Re: Napa River Sediment TMDL

You have asked me to review the Proposed Basin Plan Amendment: Napa River Sediment Reduction and Habitat Enhancement Plan and the Napa River Sediment TMDL Staff Report dated June 30, 2006.

Revised  
**Napa River near St. Helena**  
**Peak Discharge vs. Stage, Adjusted for Datum Changes**

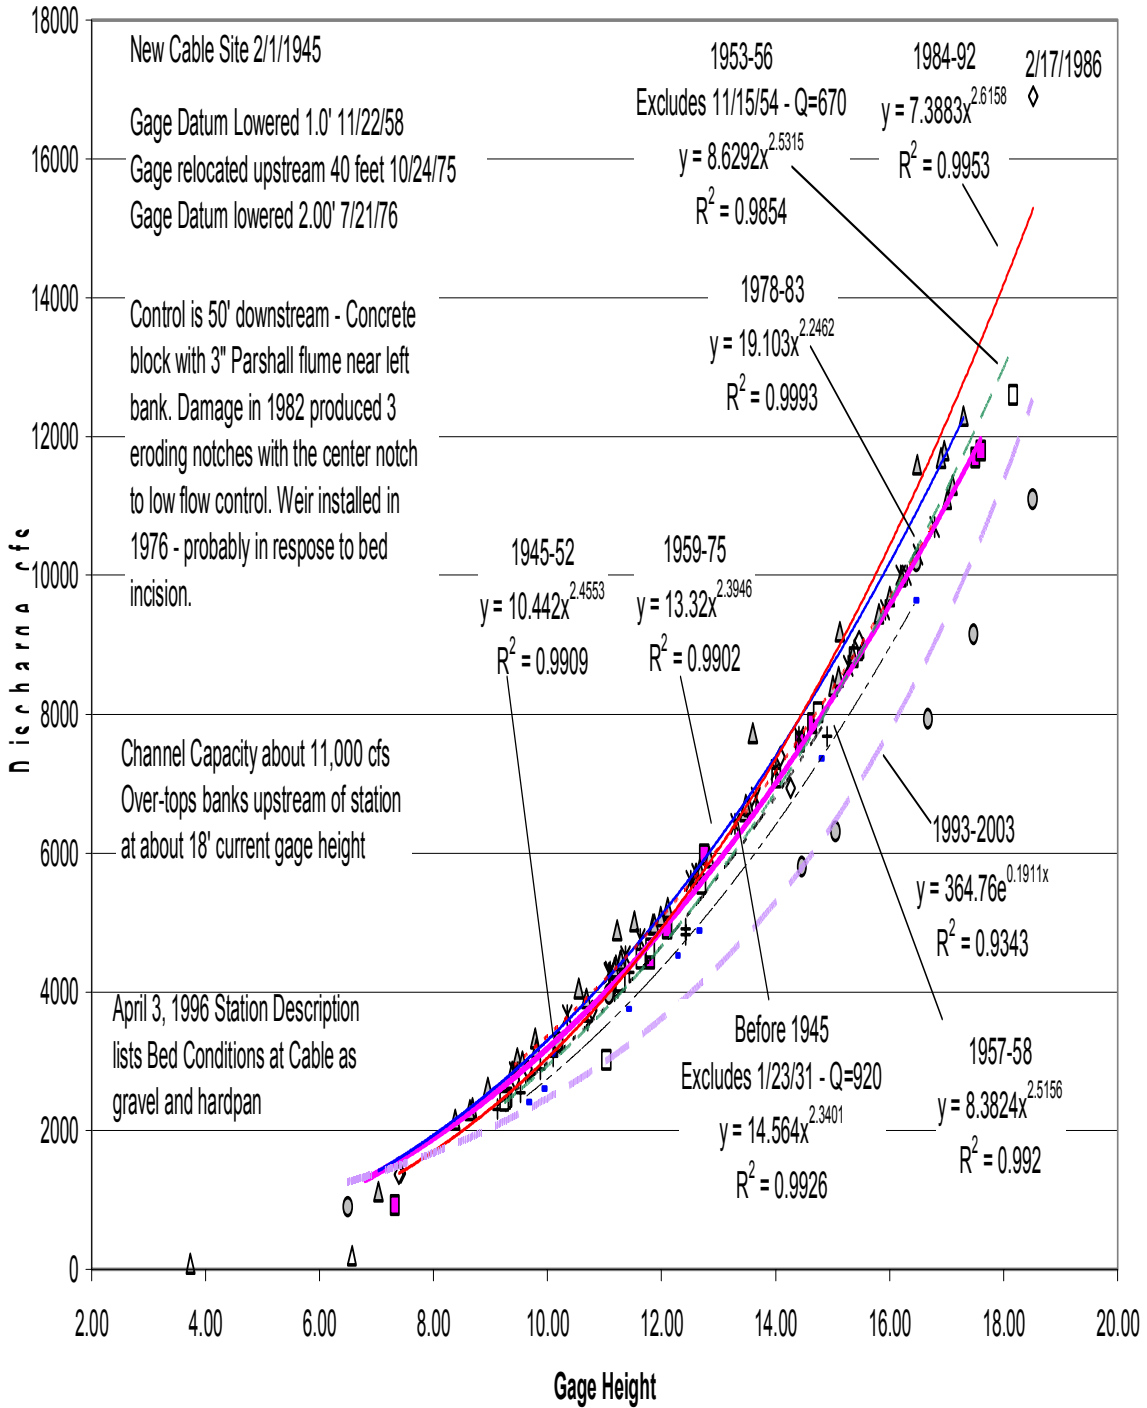
The riverbanks are eroding and failing where agricultural development has reduced or eliminated natural riparian forest and where misguided bank protection efforts have concentrated lateral erosion. This bank-cutting is caused both by the frequent channelized high flows of the river itself and by pore-water pressure in the oversteepened streambanks. Today it takes a discharge of about 11,000 cfs to overtop the channel just upstream of the St. Helena gauging station. Although this

site is not natural and unaltered, it appears to have overtopped at substantially smaller flows (as little as 5000 cfs, or close to the 2-yr return interval) 50 years ago. This opinion is based on an analysis of the complicated gauging records for the Napa River near St. Helena US Geological Survey station (Figure 1, *spreadsheet available on request*). Significantly, the trends of aggradation and incision in the main Napa River channel have not been consistent. Major floods have altered and even reversed briefly the channel cutting trends, as have channel maintenance activities (based on review of all historic meeting notes of past Supervisors' meetings up to 1996). However, the trend today is toward deeper channel incision and some channel widening.
